Appl. No. 10/659,933
Amdt. Dated February 28, 2006
Reply to Office Action of November 30, 2005

The present invention relates to a throw-away style cutting tip used for cutting a cast iron and a steel. (Applicant's specification, at p. 1, lines 5-6).

FIG.3

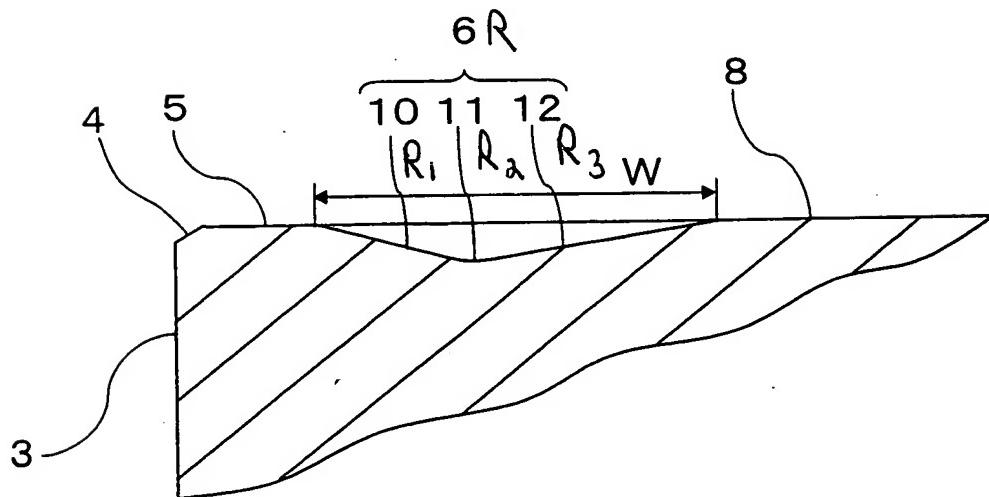
The attached sheets of drawings include changes to Figure 3.

The drawings are objected to under 37 C.F.R. 1.83(a) because they fail to show R, R1, R2 and R3 as described in the specification at p. 9, line 23-p. 10, line 15 and this structural detail is essential for a proper understanding of the disclosed invention. The Applicant respectfully disagrees.

The Office states that the disclosure is objected to because of the references R, R1, R2 and R3. As discussed above, Figure 3 was amended to include the references R, R1, R2 and R3. Withdrawal of this objection is thus respectfully requested.

The Applicant respectfully submits that the specification at p. 9, line 23-p. 10, line 15 lists reference numerals together with R, R1, R2 and R3 and this information allows for a proper understanding of the disclosed invention. However, in order to expedite the prosecution of the instant application, the Applicant added the references R, R1, R2 and R3 to Figure 3. Withdrawal of this objection is thus respectfully requested.
